A1 Birtley to Coal House

Applicant's Responses to ExA's Second Written Questions - Appendix 2.0E - Structure Options Report 11 - PCF Stage 3 - Allerdene Viaduct

**PCF Stage 3 – Allerdene Viaduct
Structure Option Report No.11**

Safety Engineering & Standards (SES) Record Sheet					
Scheme Name:	Birtley to Coal House Scheme – PCF Stage 3 – Allerdene Viaduct	<u>Comments Sheet Document Control</u>			
		Comment sheet version	Date HA comment sheet	Date Designer's reply sent	Notes
Document Ref	HE551462-WSP-SBR-S3-BR010-X-RP-CB-00001-P01.2	A	25/01/2019	22/03/19 Updated Response 28/03/19	
		B			
AIP version		C			
		D			
AIP Date	19 December 2018	E

Drawing Title: **ALLERDENE BRIDGE (SINGLE SPAN)
INDICATIVE GROUND IMPROVEMENT
OPTION - RIGID INCLUSIONS**

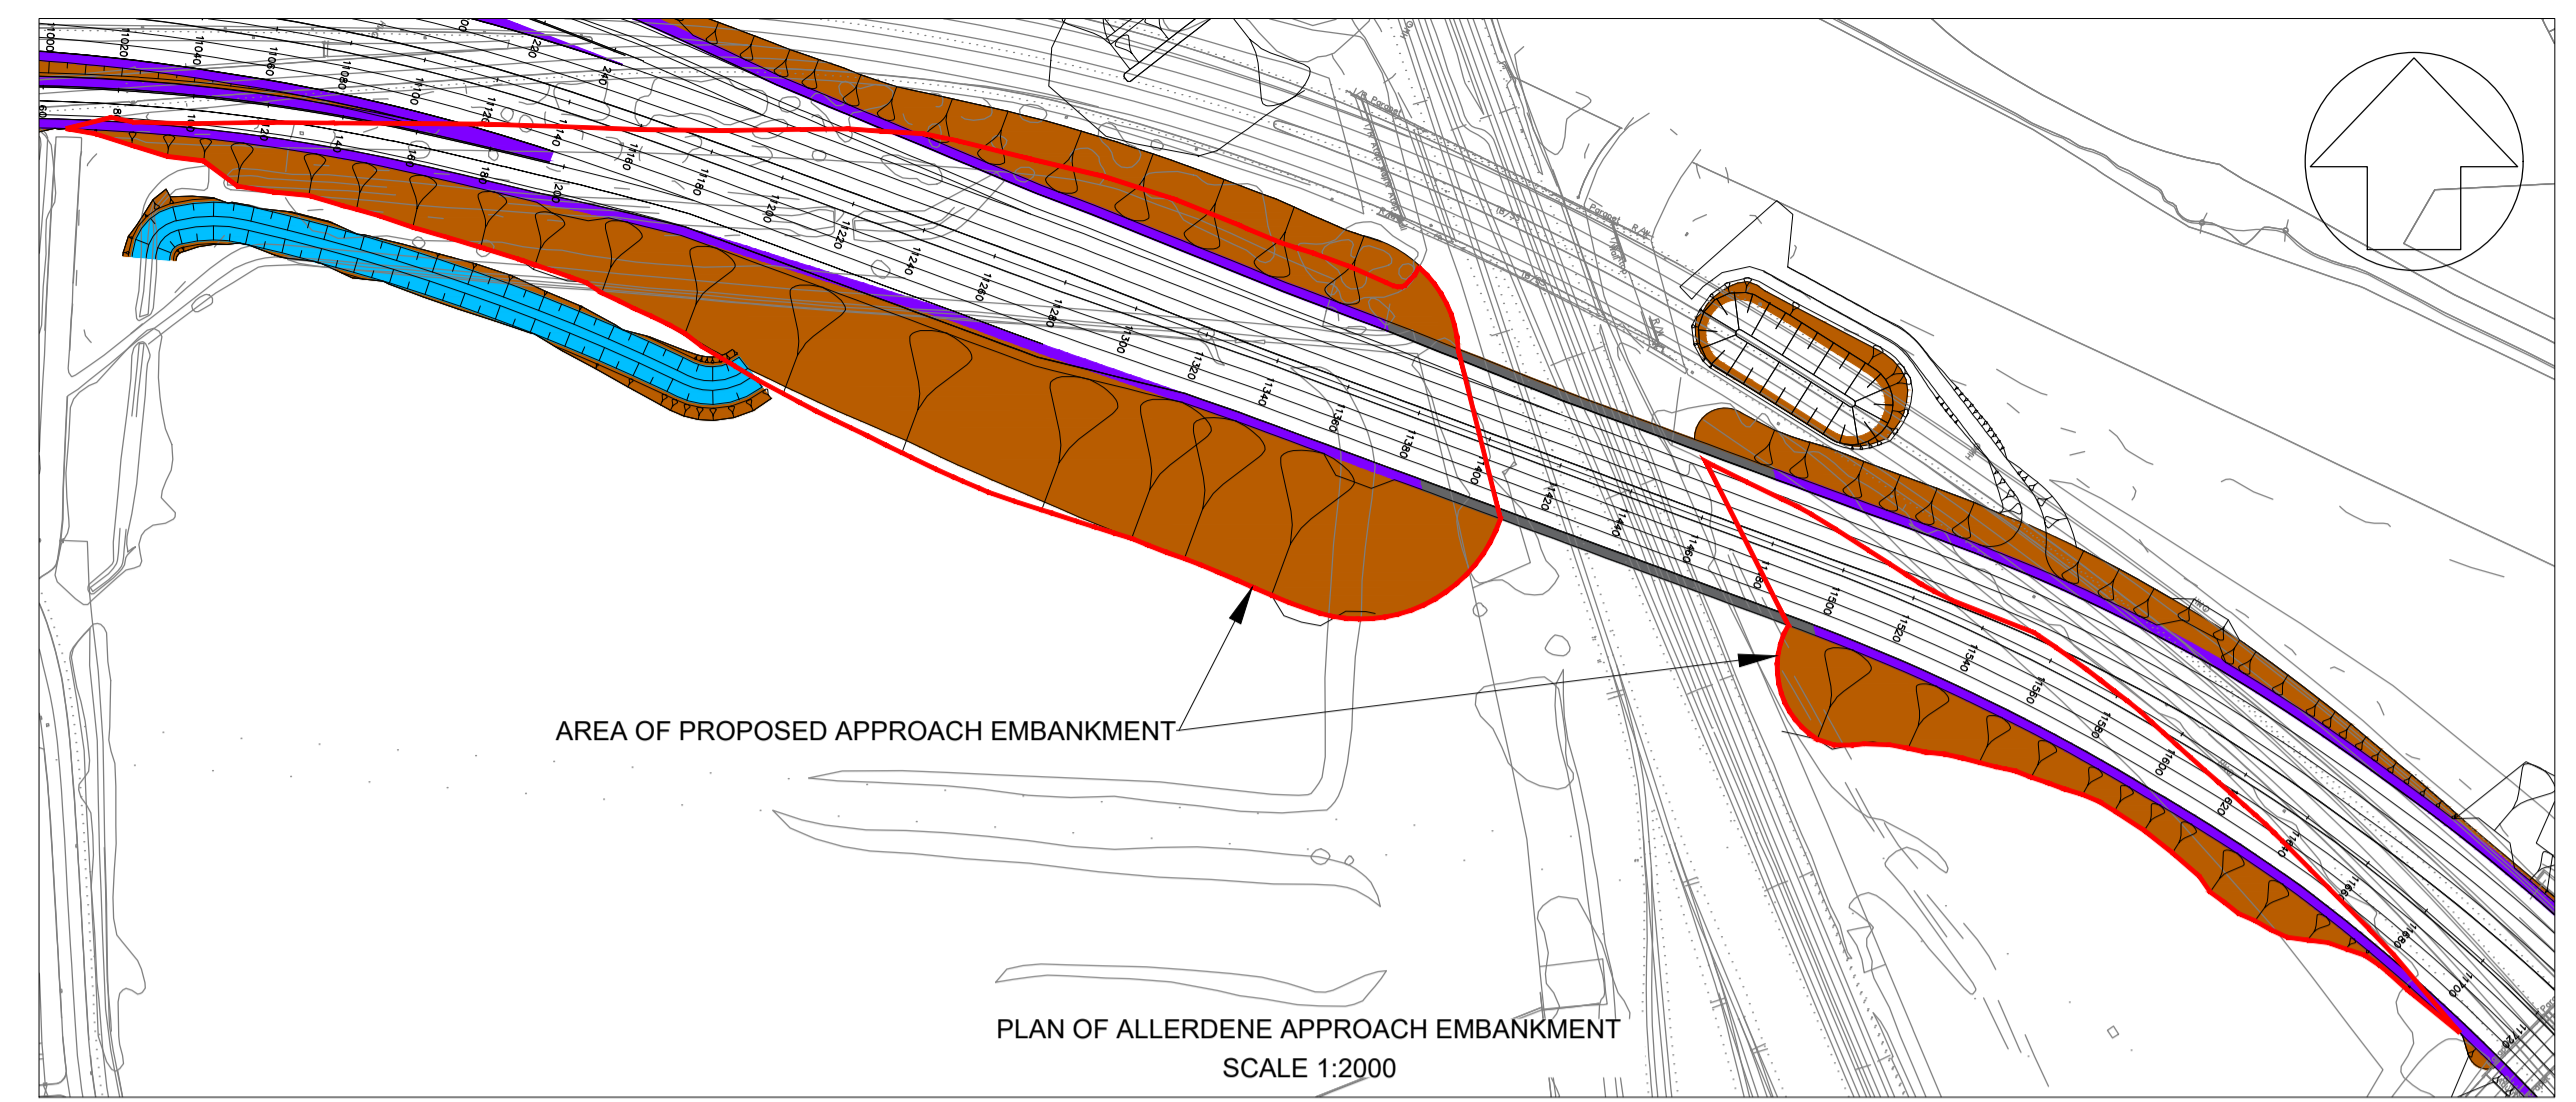
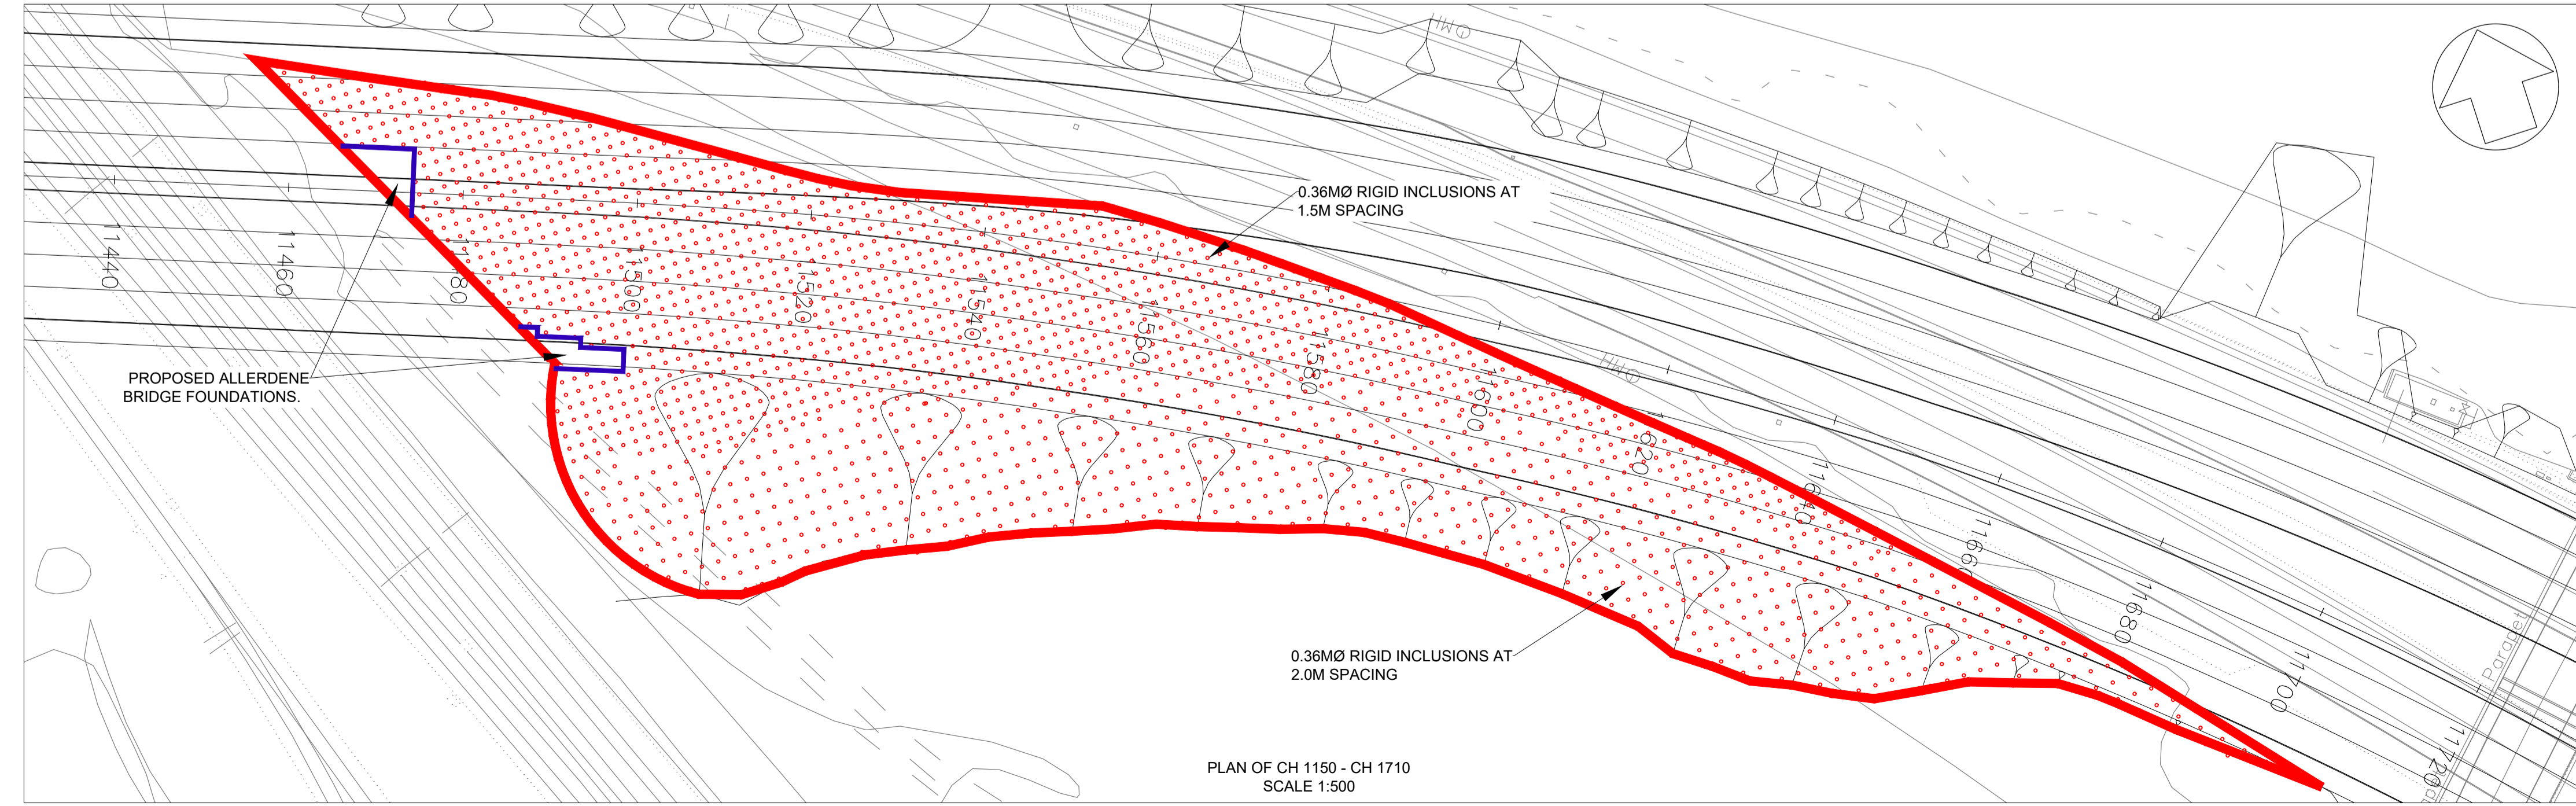
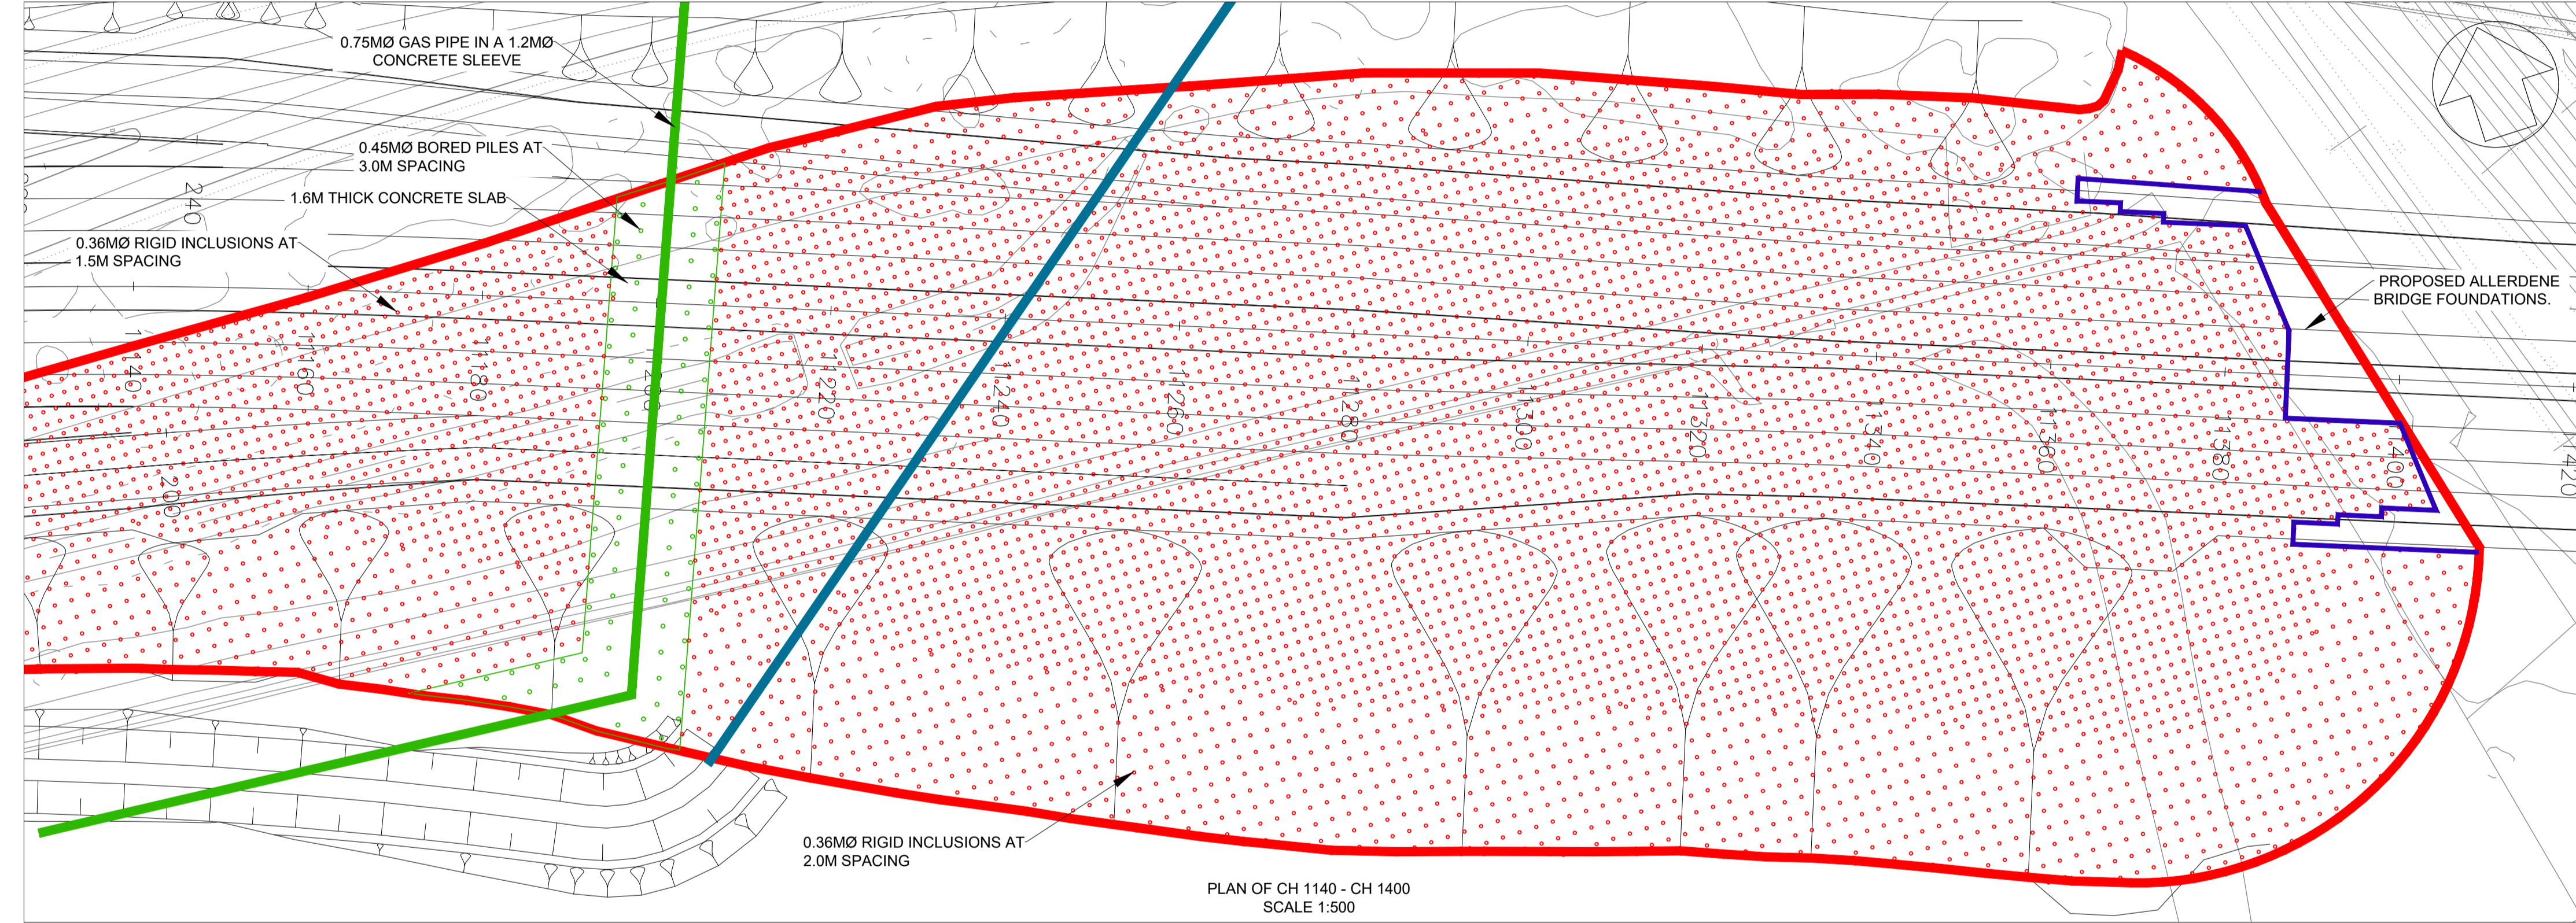
<p>c) Why rigid inclusions are deemed necessary in proximity of and under the existing embankment where over-consolidated ground should be expected (drawing 00107)?</p>	<p>Our view is an extended viaduct length would provide the most robust solution to address ALL the above. Brief details of why smaller span structures have not been considered was highlighted in the conclusion. Some of this information shall be highlighted in section 4.1 of the report.</p> <p>Rigid inclusions are needed within the existing embankment footprint where the proposed embankment is higher than the existing (i.e. increased loading), including on the existing embankment slopes/shoulder.</p> <p>27/03/19 Upon further review response considered adequate to close out comment without amendment to the report. We hope this is ok.</p>	
9	General	<p>Please confirm the cost of Option 2 excludes cost of Allerdene Culvert extension and NG relieving slab protection. Similarly, please confirm Option 1 includes these two structures.</p>	<p>For Option 2 (viaduct), the Allerdene Culvert will be made an open channel and the NGN diversion will be between the piers. This has been accounted for in the cost estimates.</p> <p>Costs within Option 1 include for both the culvert extension and protection slab.</p> <p>27/03/19 Clarification provided in response no change to report required.</p>

39	Drawing 0055 and 107	<p>The way rigid inclusions are shown on these two drawings is confusing. Drawing 107 seems to suggest rigid inclusions are installed under culvert and NG slab yet drawing 0055 shows they are not. Please make consistent.</p> <p>Please review notes on the geotechnical drawings and drawing numbering as there seems to be two separate drawing 107 and notes referring to other drawings that are not included.</p> <p>Why no cut-off shear wall (or similar) is identified on the drawing to help protect ECML? It should be on either side of the track down to rock level.</p>	<p>Noted. Details on drawings 0055 and 107 to be reviewed and updated accordingly.</p> <p>27/03/19 Upon further review drawing ending 0055 to be removed as causing confusion. Minor amendment to dwg 00107 to address comments</p> <p>Refer to response to Comment 6 re: cut off wall.</p>	
40	Drawing 107 – cross section through Ch. 1120	<p>What is the ditch showing? Is there geogrid reinforced granular load transfer mat on the top?</p>	<p>Ditch is shown indicatively, details to be developed at detailed design.</p> <p>27/03/19 Upon further review drawing number to be updated to avoid confusion. Reference to grid also removed as not considered to add any value at this stage.</p>
